1993-05

Model 36/41

Recoil spring

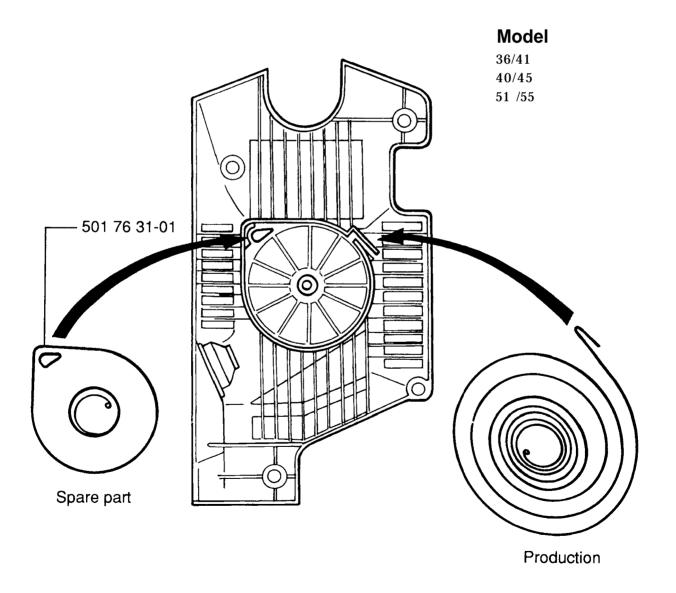
When mounting spare parts springs, mistakes can occur because spare part and production part does not have the same design.

The following is valid, see illustration.

Start with mounting the pulley on the spring cassette. Place the starter according to the illustration and bring the starter kit into the starter.

NOTE! Make sure that the starter spring cassette will get into the correct groove.
